# **FINAL CONSTRUCTION REPORT** for **MACFARLANE DAM** **REHABILITATION PROJECT**

**CONSTRUCTION FILE NO. C-1031B**  
**COLORADO DAM ID: 470202**  
**NID: CO-00997**  
**WATER DIVISION 6 – WATER DISTRICT 47**  
**JACKSON COUNTY, COLORADO**

## Final Construction Report

Appendix D – Documentation of Construction Changes

2. Close up view of the squished riveted steel pipe section located at the transition between the CMP pipe and the riveted steel pipe approximately 76 feet upstream of the outlet end of the discharge pipe.

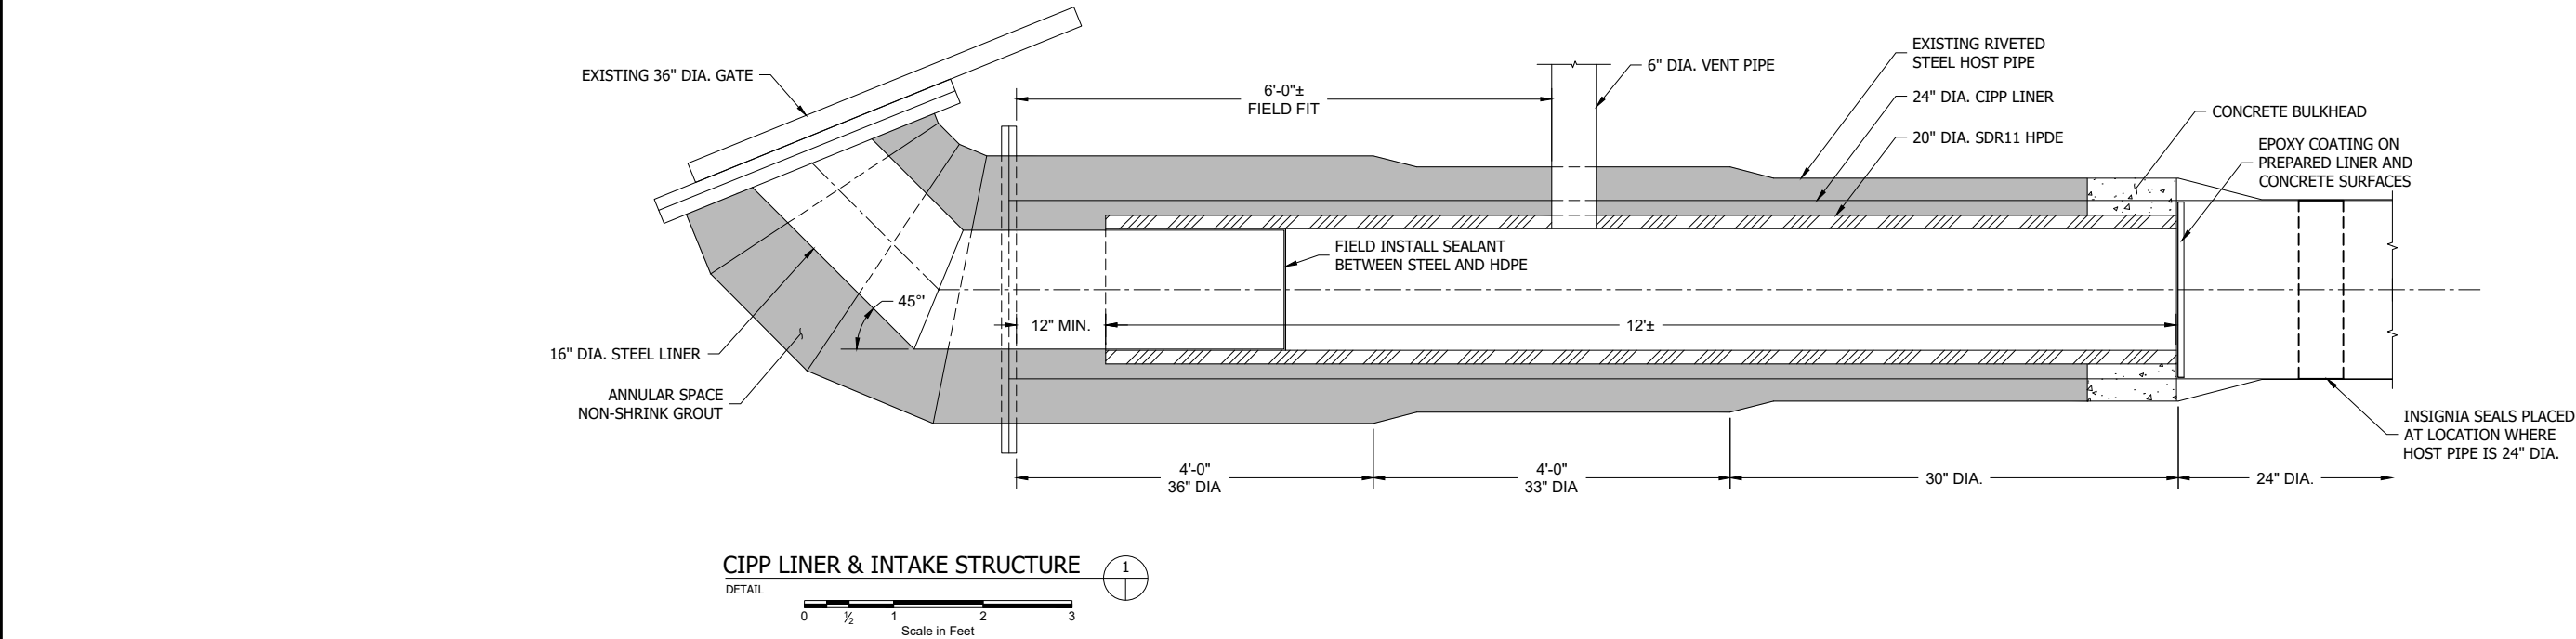
This letter documents the basis for requesting your approval to change the designed 20-inch-diameter Standard Dimension Ratio (SDR) HDPE outlet works liner pipe to a 24-inch-diameter CIPP liner. The approximate inside diameter of the CIPP liner will be 23.5 inches. This Change Order is requested based on the video inspection after the existing outlet pipe was jet cleaned and the unsuccessful 20-inch-diameter HDPE test pull that occurred on September 29, 2017.

W. W. Wheeler & Associates, Inc. (Wheeler) is requesting this Change Order on behalf of our Client, the U.S. Fish and Wildlife (FWS) for the following reasons: During the HDPE test pull on September 29, 2017, a squashed section of the existing riveted steel host pipe was discovered approximately 76 feet upstream of the downstream end of the existing outlet works conduit at the transition from the CMP pipe to the riveted steel pipe. This squashed section of pipe has significantly reduced the host pipe diameter and the designed 20-inch-diameter HDPE liner cannot be installed. Due to a limited 2017 construction schedule and the approximate lead time for purchasing smaller, 18-inch-diameter HDPE pipe, the Contractor has requested to change the liner from HDPE to a 24-inch-diameter CIPP liner. The 24-inch-diameter CIPP Liner is a more readily available product that can be installed on approximately October 30 and will not significantly impact the construction schedule. Changing from the 20-inch-diameter HDPE liner to the 24-inch-diameter CIPP liner will not significantly change the outlet works discharge capacity because the outlet discharge capacity is still inlet controlled.

Due to the high entrance velocities at the intake, a 16-inch-diameter steel pipe and a 20-inch-diameter HDPE transition section will be installed in the intake as shown on the attached intake structure detail provided on Attachment B. The HDPE transition will allow the contractor to still install the air vent in the HDPE transition section as originally designed as well as providing a transition section to reduce flow velocities from the 16-inch-diameter steel insert to the new CIPP liner. The annular space between the new CIPP liner and the existing host pipe will be filled with the specified non-shrink grout and concrete bulkheads will be installed prior to grouting this annular space.
